Level 2 floor finish plan

A-102

ADDENDUM 1

Lobby finish revision

LEVEL 2 / OPENING MARKS

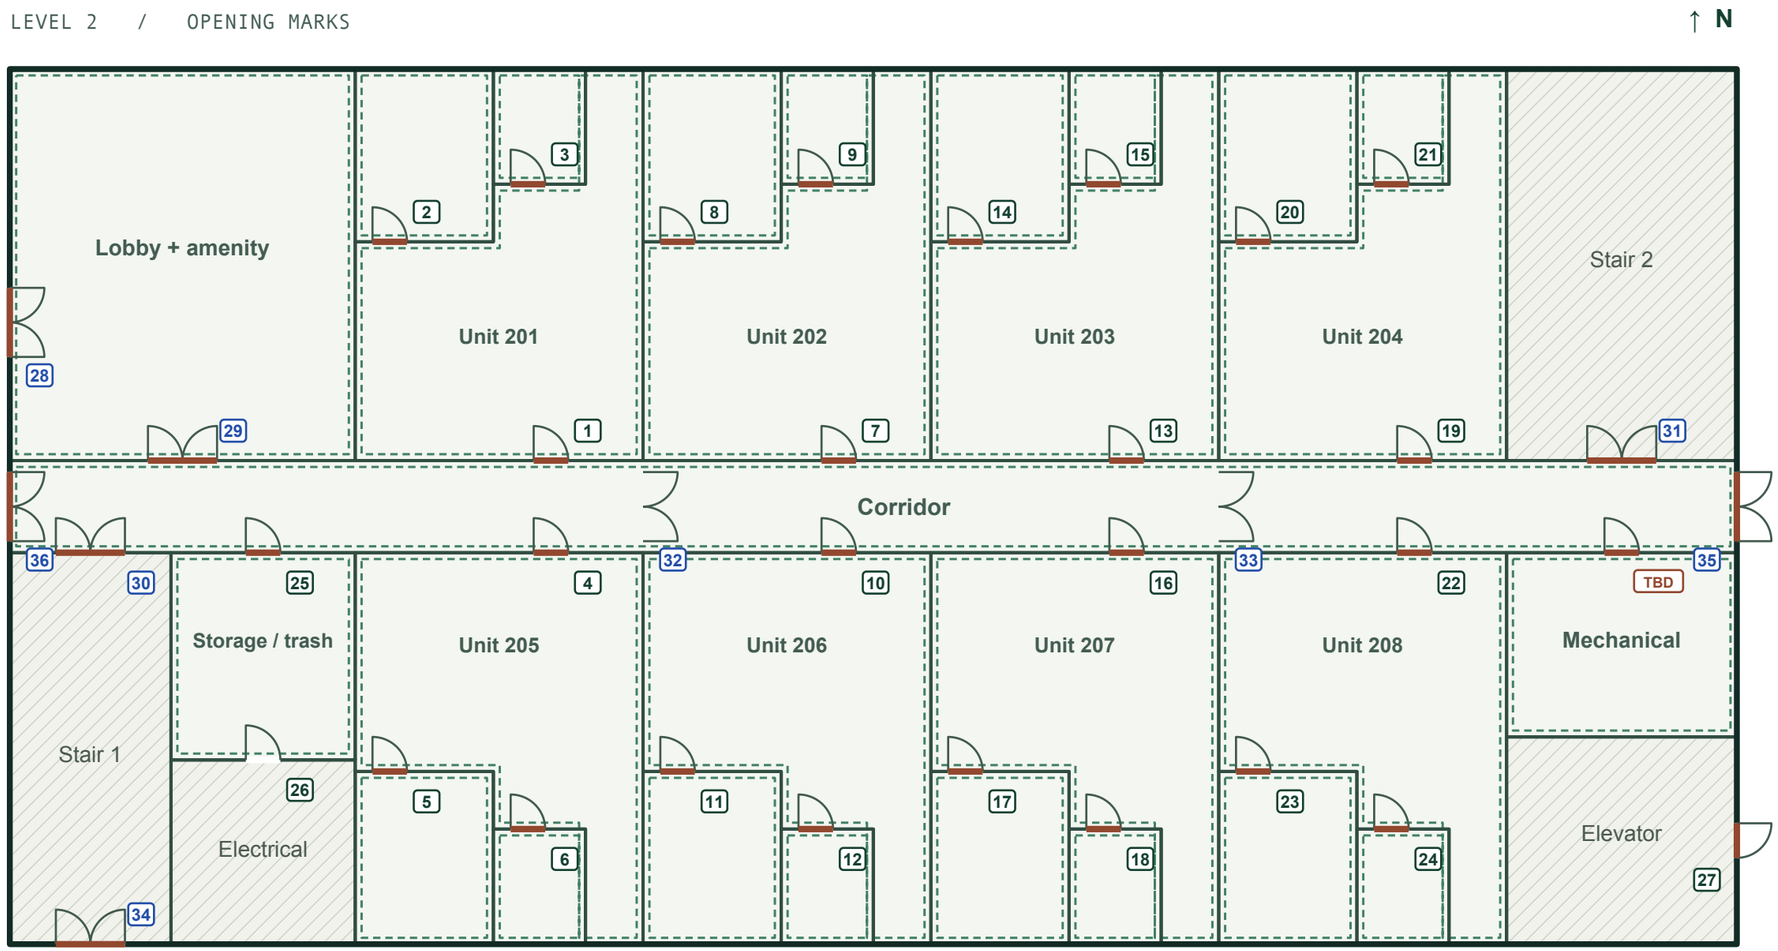
See page 3 for opening 38 and the revised base and transition quantities.

LOBBY DETAIL / REVISED

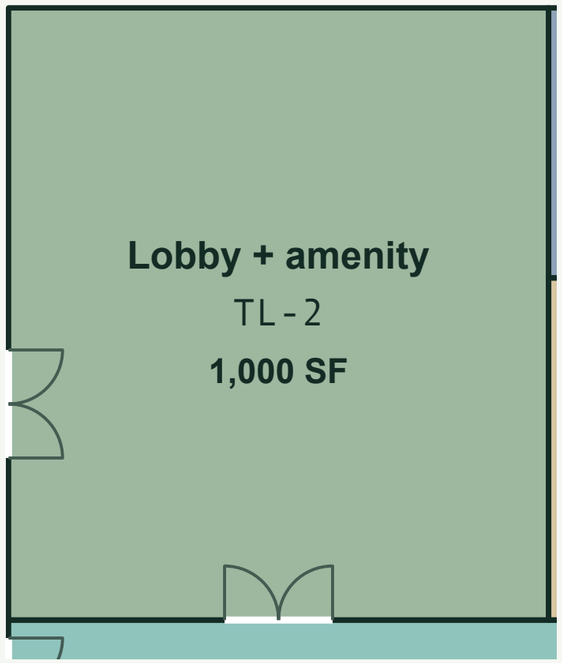
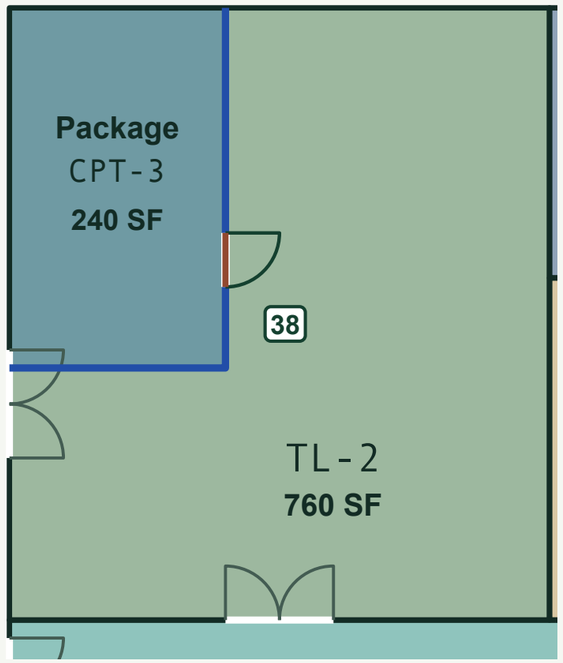
A 240 SF package room takes the northwest corner of the lobby. Its new door is opening 38.

Item	Base	Change	Revised
TL-2 Lobby porcelain	1,000 SF	−240 SF	**760 SF**
CPT-3 Walk-off carpet tile	0 SF	+240 SF	**240 SF**
CPT-3 Trade quantity	0.0 SY	+26.7 SY	**26.7 SY**
RB-1 Rubber base	2,064 LF	+18 LF	**2,082 LF**
Transitions	34 EA	+1 EA	**35 EA**
Openings	37 EA	+1 EA	**38 EA**

The 26.7 SY of walk-off carpet covers the same 240 SF shown in the finish schedule.

One new single brings the count to 28 singles, 9 pairs and 1 opening with type pending.

CPT-1, CPT-2, LVT-1, TL-1 and SC-1 retain their base quantities.
